INITIAL FIRE SAFETY ASSESSMENT - EXPANSION

Factory Name: **Adury Apparels Ltd.**
Address: **Karardi, Shibpur, Narsingdi, Narsingdi Dhaka
Bangladesh**
Assessor: **Shaheedullah**
Date: **08 Oct 2017**

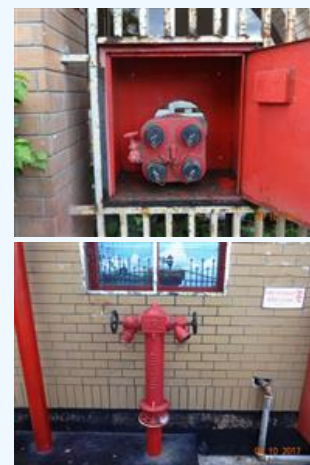
Suggested Deadline Date:	25 Apr 2018
Standard:	Alliance Standard Part 5 Section 5.5.4 Fire Department Connections
Question:	Are portable fire extinguishers installed throughout the building at required locations and mounted at the correct height?
Priority Level:	Medium
Non-Compliance Level:	2
Description:	Portable fire extinguishers are installed on the exterior walls at a correct

height, but they are not available within 100 ft of the production floor. The current distance was measured to be 124 feet.	
Source of Findings:	Photograph: The production floor., Visual Assessment: The facility Survey.	
Suggested Plan of Action:	Install fire extinguishers at locations and heights based on the hazard type per BNBC Part 4 and NFPA 10.	
Suggested Deadline Date:	24 Dec 2017	
Standard:	BNBC Part 4 Section 4.10 and NFPA 10
